10/606,452 PATENT

REMARKS

APPENDIX A

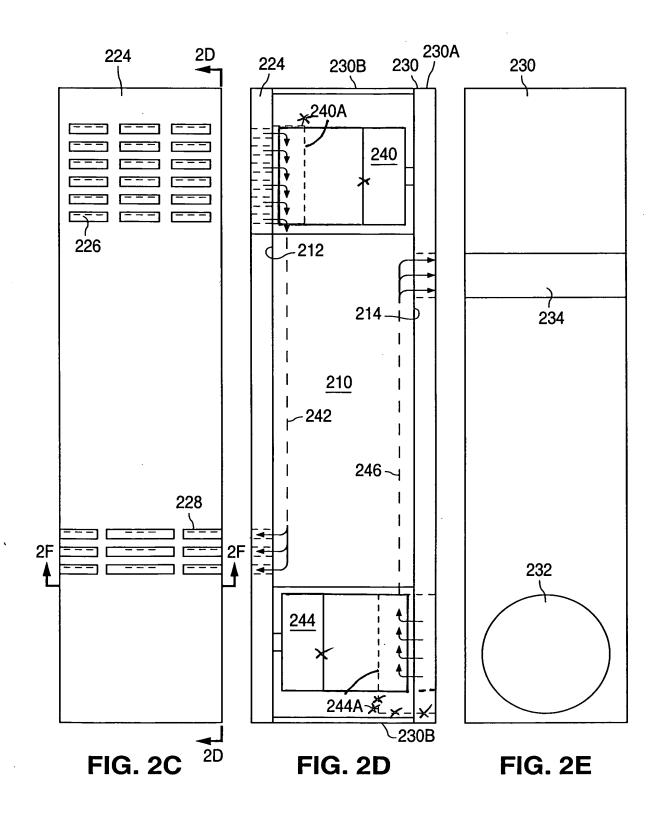
The Examiner objected to the drawings under 37 CFR 1.83(a) because the drawings show fans 240 and 244 spaced apart from their respective openings 226 and 232 by an excessive amount. The purpose of the drawings, however, is to illustrate the invention, not to show production level detail. With this standard, one skilled in the art would readily understand the invention in view of the present drawings, and would easily be able to determine an acceptable position of each fan with respect to the openings without undue experimentation.

However, in an effort to further prosecution, FIG. 2D has been amended as shown in red on a marked-up copy of FIG. 2D to show a fan more closely positioned to the openings. The marked-up copy of FIG. 2D is attached in Appendix A. In addition, applicant wishes to replace the informal drawings filed with the application with the replacement sheets attached in Appendix B, which includes a replacement
